LORMEL DEVELOPMENTS (BRADFORD) LTD.
PURCHASER EXTRAS

LOT-108 P.E #002 – Kimberley – 3020 - Elev.C

Schedule B-3 – Purchaser’s Extras
forming part of the Agreement of Purchase and Sale

MODEL: Kimberley 3020

Refer
To
DC-7412

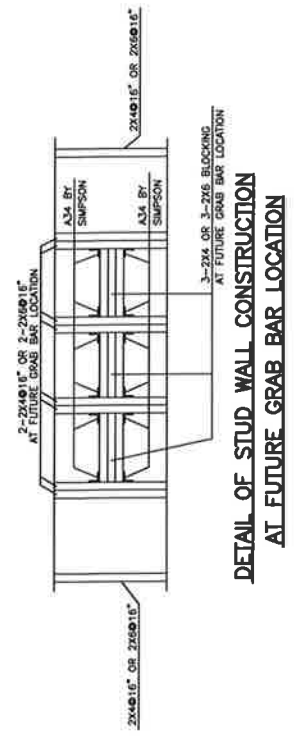
Re-Center
soc.
↓
1/4
abnorm

Relocate.
+ replace.

FIRST FLOOR PLAN

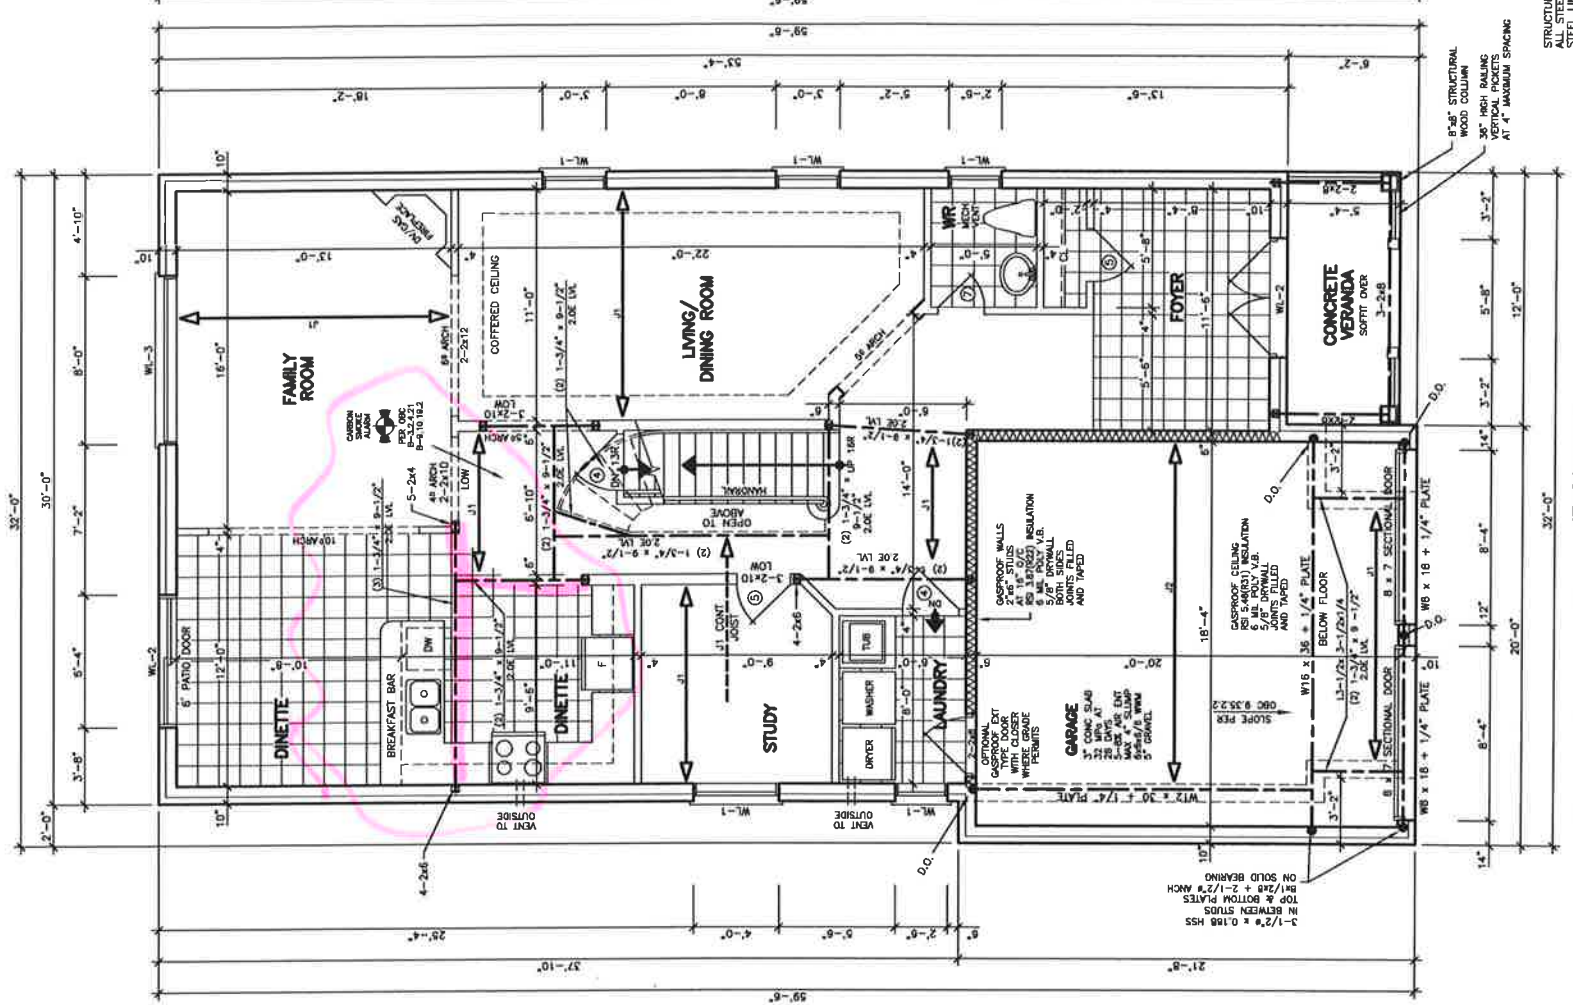
No.	DESCRIPTION
1.	Relocate the standard fireplace in the family room to the opposite corner. Purchaser understands that window in the family room may need be shifted towards the kitchen in order to accommodate 48 60" FIRE WINDOW

2.	In lieu of a full wall, provide a trimmed opening (as wide as possible) between the living room and family room Reduce wall between the kitchen and main hallway to approx. 30". Refer to sketch attached. Increase the opening between the family room and dinette as wide as possible Cost to provide additional support

3.	In lieu of the peninsula, provide and install an island with breakfast bar. Relocate the sink and dishwasher to island. Island to be approximately 2 x 6 with bar top counter. Increase the length of the cabinetry along stove wall to line up with island. (approximately 1ft) Recenter the stove based on revised layout.

4.	Cost includes the additional standard cabinetry and standard granite required Provide and install counter depth fridge enclosure with double gable. In lieu of upper and lower cabinets next to fridge, provide and install pantry (approx. 18" wide by 24" deep)

5.	Provide for 10ft ceilings throughout the main floor in lieu of standard, (does not include areas where bulkheads are required). All main floor door heights will be increased (front doors and rear patio doors) plus all main floor windows will be increased by 6" in height (based on standard white frames) STANDARD HEIGHT INTERIOR DOOR & ARCHWAYS. Please note, in the event the Purchaser proceeds with 10ft ceilings throughout the main floor, Purchaser understands there will be a space between the upper cabinets and the bulkhead
H.S.T. New Total: (\$ Less Bonus Package (if Applicable) TOTAL: Amount to be added to the purchase price as an adjustment on closing	
TOTAL
